# **Richmond Bridge Approaches- Intersection Upgrade at March Street and Bosworth Street, Richmond**

**Addendum review of environmental factors 5- Property Adjustment at 35 Bosworth  
Street**

**Transport for NSW**

June | 2020

**Figure 1-1: Location of the proposed modification**

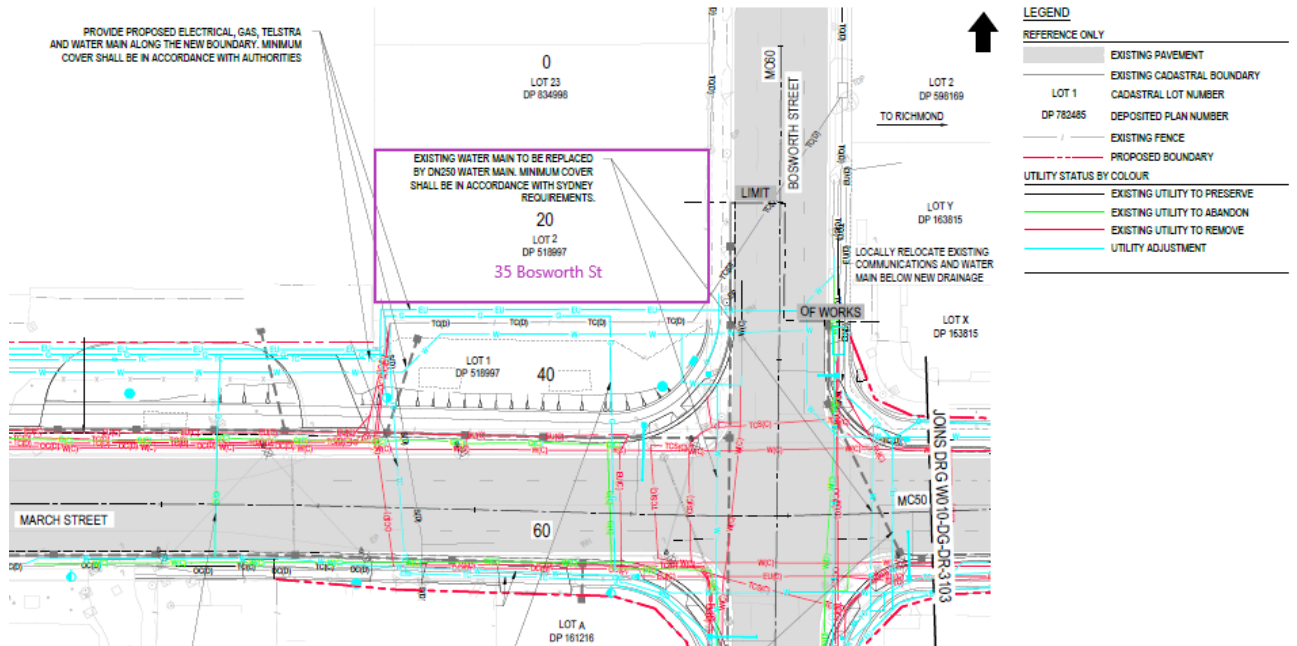
Transport for NSW proposes to modify the *Richmond Bridge and Approaches- Intersection upgrade at March Street and Bosworth Street*, Richmond by adjusting the boundary fence at 35 Bosworth Street so that it no longer encroaches on Transport for NSW Property (proposed modification) to allow for utilities adjustments to take place. Key features of the proposed modification would include:

- Removing the existing fence at 35 Bosworth Street that currently lies on Transport for NSW land
- Demolishing a small shed on the exterior of the house to allow for property realignment
- Removal of two mature exotic trees within the Transport for NSW property. Both trees are of a similar size and are approximately four metres high and between 300 - 400 millimetres in diameter at breast height. One of the trees appears to be dead or dying, while the other tree appears to be healthy
- Rebuilding the property fence at the correct cadastral boundary.

The proposed modification is shown in Figure 1-1 and Figure 1-2. Chapter 3 describes the proposed modification in more detail.

**Figure 2** Study area with proposed works

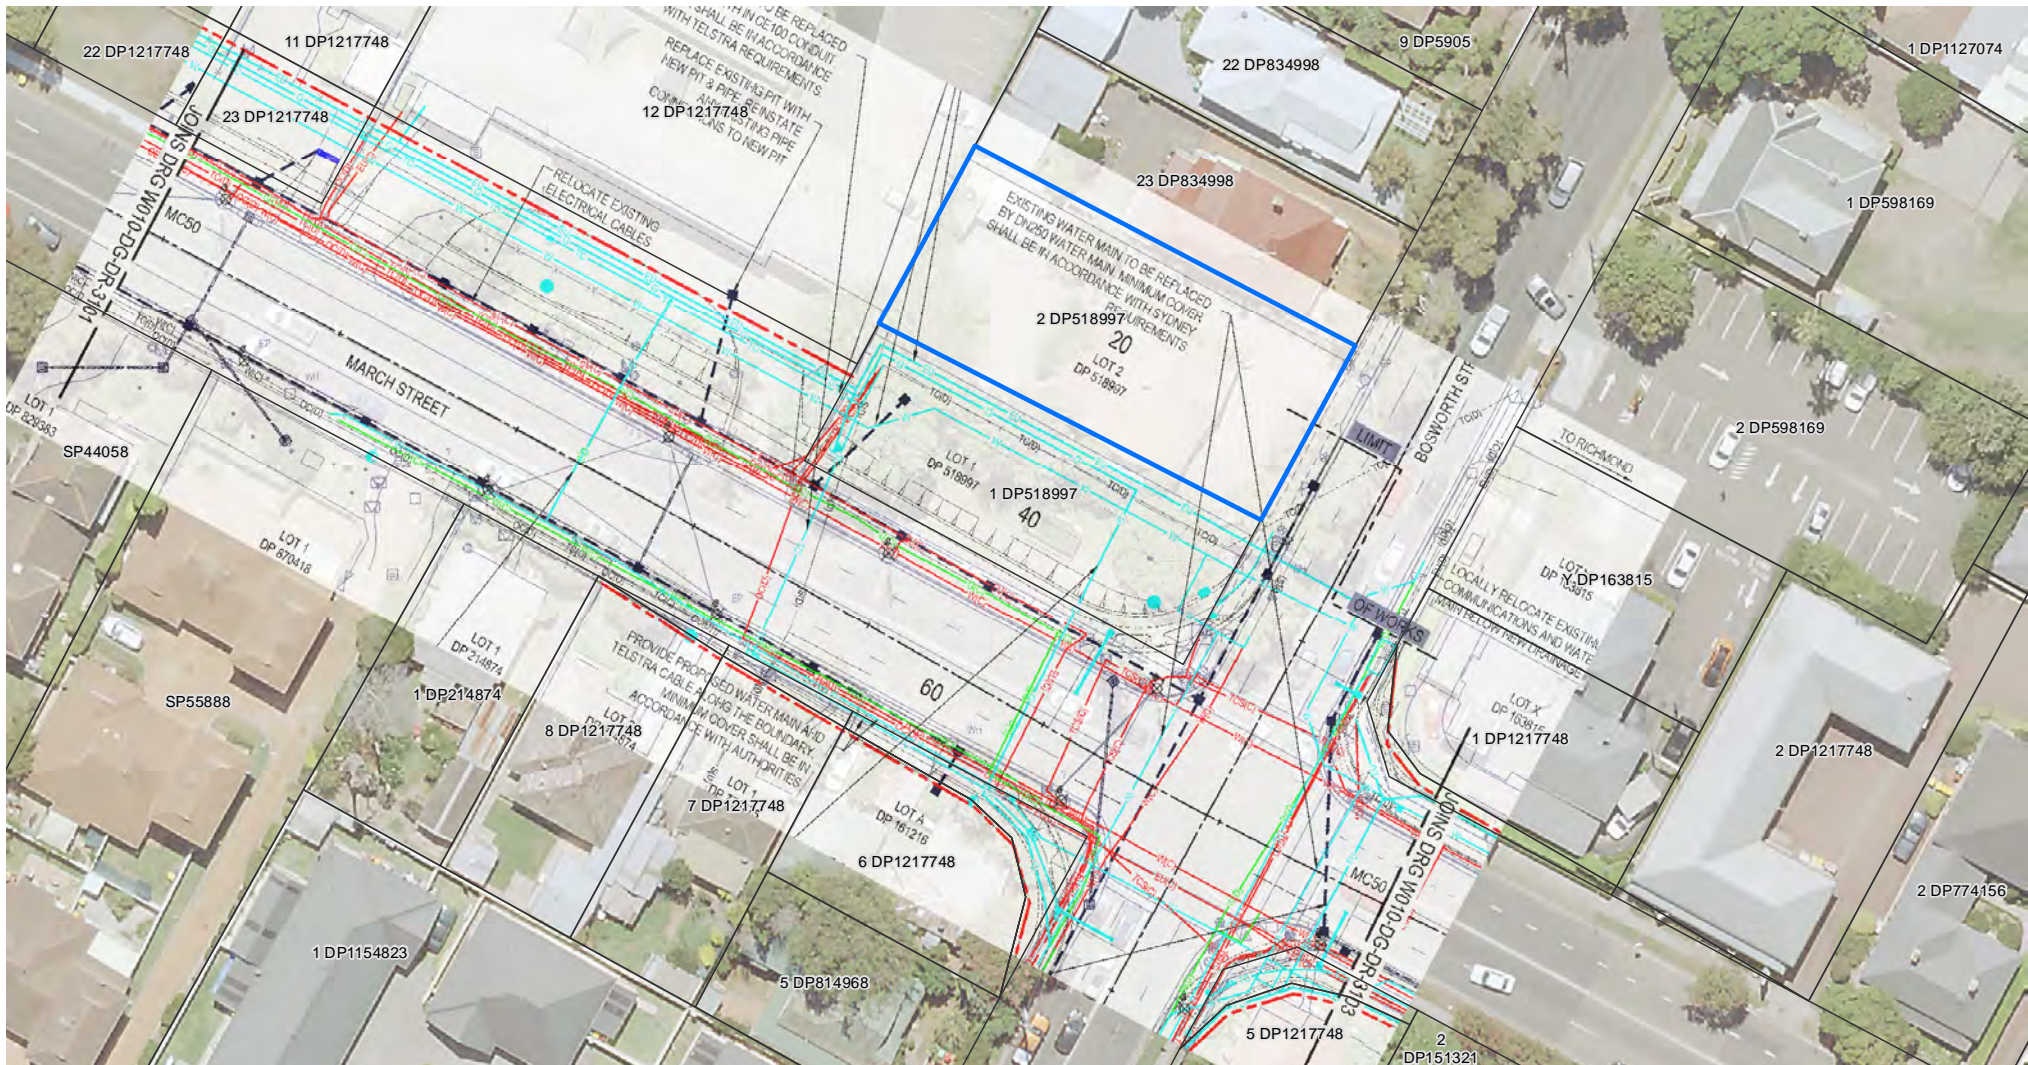
It has since been established that the southern fence for the item is outside of its cadastral boundary and lies on the adjoining block owned by Transport for New South Wales (TfNSW). Utility relocation works associated with the intersection upgrade are planned for the area currently occupied by the fence, requiring it to be moved 3-4 metres back to the cadastral boundary for the item. This will necessitate the removal of two trees and a shed within the heritage curtilage of the item (Figure 2).

**Figure 2** Study area with proposed works

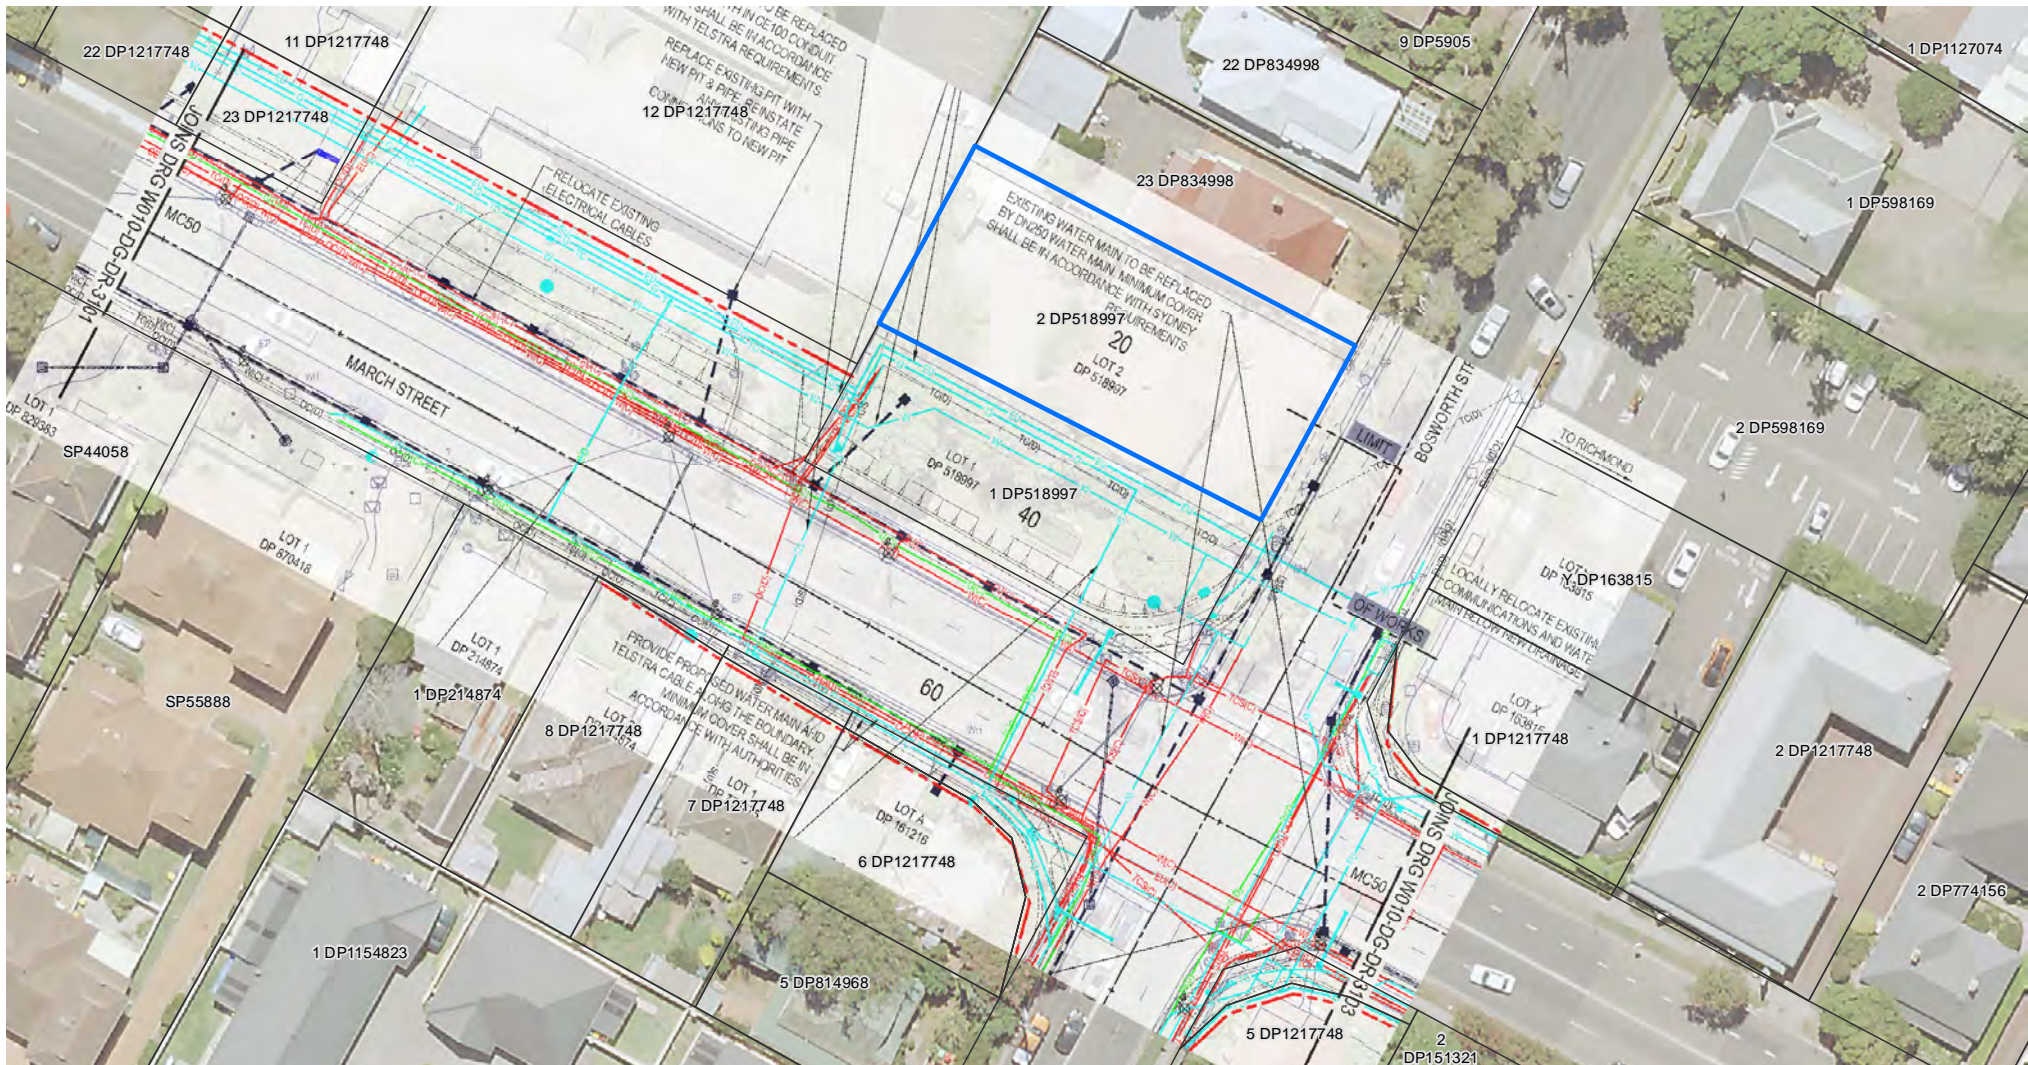
It has since been established that the southern fence for the item is outside of its cadastral boundary and lies on the adjoining block owned by Transport for New South Wales (TfNSW). Utility relocation works associated with the intersection upgrade are planned for the area currently occupied by the fence, requiring it to be moved 3-4 metres back to the cadastral boundary for the item. This will necessitate the removal of two trees and a shed within the heritage curtilage of the item (Figure 2).
